ARMENIAN CHURCH AND CULTURAL CENTER JSP17-37

ARMENIAN GENOCIDE MEMORIAL JSP 17-37

PLANNING REVIEW

JSP 17-37 ARMENIAN CHURCH AND MEMORIAL

1 Enlarged Section
 Scale: 1/8" = 1'-0"
 0' 2' 4' 8' 16"

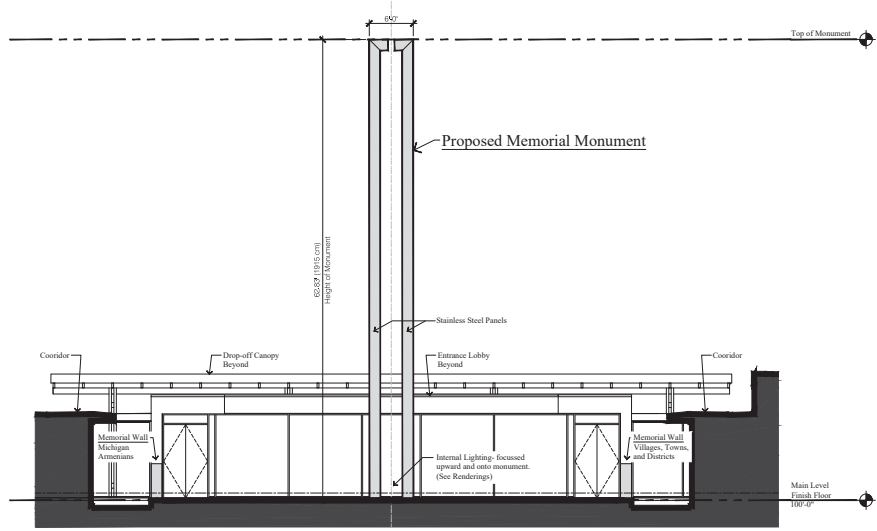
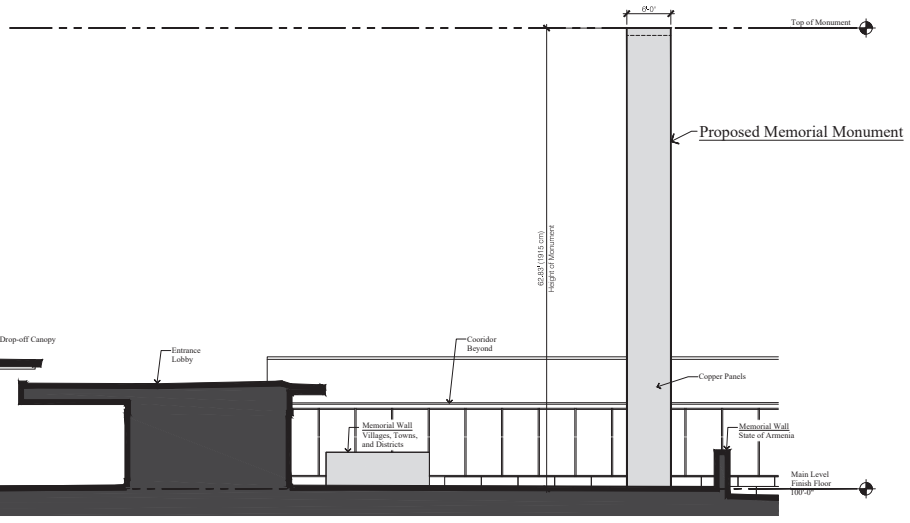
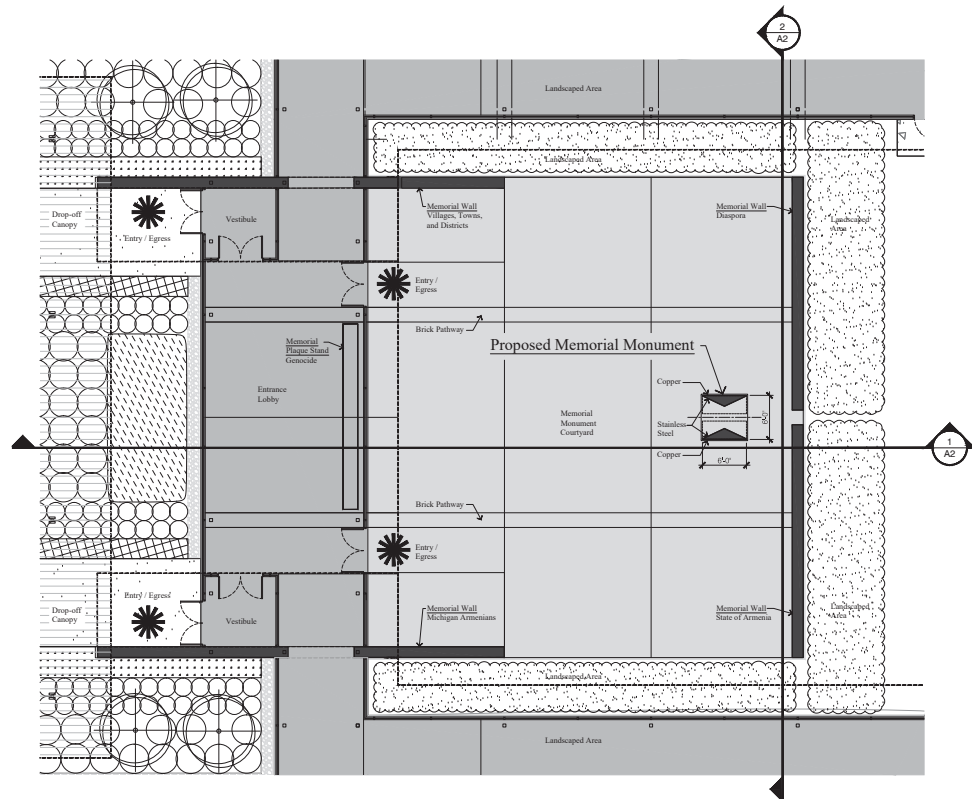
2. **Building height:** The proposed height of the Genocide memorial is 62.83 feet, or 1915 centimeters. As explained in the applicant’s narrative, the height represents the year the genocide began, 1915. In the RA District, the height limit is 35 feet, however this limit does not apply to “church spires” and “public monuments,” which the proposed structure may be interpreted to fall under. Section 3.32.3 states: *The height limitations of this Ordinance shall not apply to farm buildings, chimneys, church spires, flagpoles, public monuments or commercial wireless transmission towers; provided, however, that the Zoning Board of Appeals may specify a height limit for any such structure requires authorization as a special land use and provided further that the height of any such structure shall not be greater than the distance to the nearest property line.*

The proposed monument structure is greater than 63 feet from all property lines. Because the memorial does not appear to fall into any of the exceptions, the ZBA will need to specify the height as requested by the applicant.

3. **Lighting and Photometric Plan (Sec. 5.7):** All proposed developments abutting residential districts require a photometric plan and exterior lighting details at time of Preliminary Site Plan. **However it appears the only new exterior lighting proposed would be lighting directed upward to illuminate the memorial structure. As this light could have an impact on neighboring properties, it is important for the Planning Commission to have full details of the lighting proposed in making a determination for Special Land Use approval. The applicant shall provide more information on the lighting proposed for the memorial such as type of light bulb, color of light, whether it is single stream of light or flashing, hours of operation etc.**

- o The top of the memorial structure does restrict the projection of light into the night sky, but does not completely block it. As it is designed a ray of light would project above the structure. **The Planning Commission may waive the cut-off requirement in this case if it determines it is otherwise meets the considerations for lighting plan review, as stated here:**

The proposed Memorial Monument is located between the buildings within the Armenian Genocide Memorial Courtyard. This courtyard is located centrally within the overall 19.35-acre site. The site consists of varied terrain, a large amount of existing tree growth, and a significant amount of added new landscape. The monument is designed as an architectural element with both copper and stainless-steel panels. The lighting proposed for the Memorial Monument shall be a single stream of upward light originating from the fixtures located at the base of the structure and will radiate upward focused on the full height of the monument. The stream of light will be focused onto the structure and will not shine onto or toward any of the adjacent properties at any time. The LED fixtures will have a color temperature of 3000K - 3500K and will provide their maximum light output directly onto the surface of the structure. The light intensity above the monument will taper off, and by 200'-0" above the base, the light will be imperceptible. It is proposed for the monument to be illuminated for a limited amount of time per day. The lighting system can be controlled and altered seasonally, as needed.
